Access Compliance Report

Public Rights-of-Way

(Curb Ramps)

Intersection ID: 2949	Main Street: DOWNFIELD_WOOD_DR	Cross Street: LADY_BANK_DR	Location: W
ADA ID: D56BBDE7A8B6	Ramp Type: Perp	Initial Pass/Fail: Fail	Overall Compliance: No
		Severity Score: 12.5	
Codes/Mitigation Info/Possible Solution		Field Measurements/Component Compliance

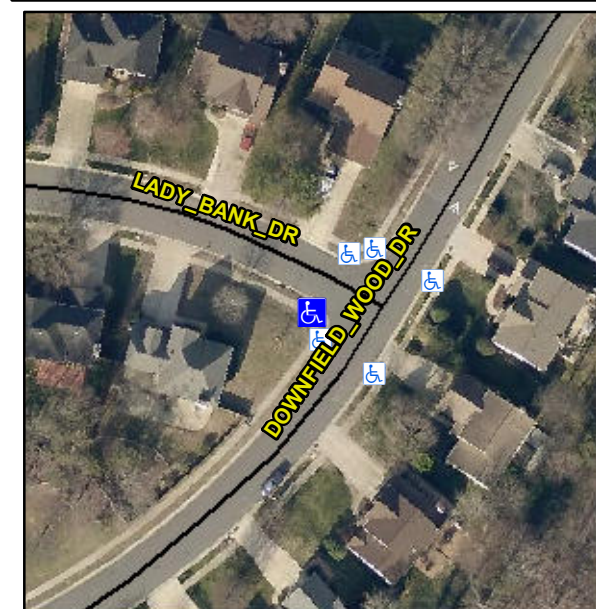
Not Found, R304.2.2

Compliance	Description	Data	Compliance	Description	Data
N/A	Ramp Length (in)	54.0	No	Ramp Slope (%)	9.3
Yes	Ramp Width (in)	84.0	Yes	Ramp XSlope (%)	1.7
N/A	Flare Type LT	N/A	N/A	Flare Type RT	N/A
N/A	Flare Slope LT (%)	N/A	N/A	Flare Slope RT (%)	N/A
N/A	Flare Traversable LT?	N/A	N/A	Flare Traversable RT?	N/A
N/A	Landing Length (in)	N/A	N/A	DWS Provided?	N/A
N/A	Landing Width (in)	N/A	N/A	DWS Contrast?	N/A
N/A	Landing Slope (%)	N/A	N/A	DWS Length (in)	N/A
N/A	Landing X Slope (%)	N/A	N/A	DWS Full Width?	N/A
N/A	Landing Curb? (Y/N)	N/A	N/A	DWS Offset (in)	N/A
N/A	Shared Landing?	N/A			
N/A	Gutter Ponding?	N/A	N/A	Gutter Slope (%)	N/A
N/A	Gutter Lip Ht (in)	N/A	N/A	Gutter X Slope (%)	N/A
N/A	Painted X Walk1?	No	N/A	Painted X Walk2?	N/A
	X Walk 1 Direction	To NE		X Walk 2 Direction	N/A
N/A	X Walk 1 Width (in)	N/A	N/A	X Walk 2 Width (in)	N/A
	X Walk 1 Slope (%)	0.4		X Walk 2 Slope (%)	N/A
	X Walk 1 X Slope (%)	1.5		X Walk 2 X Slope (%)	N/A

Remove & Replace Entire Ramp.
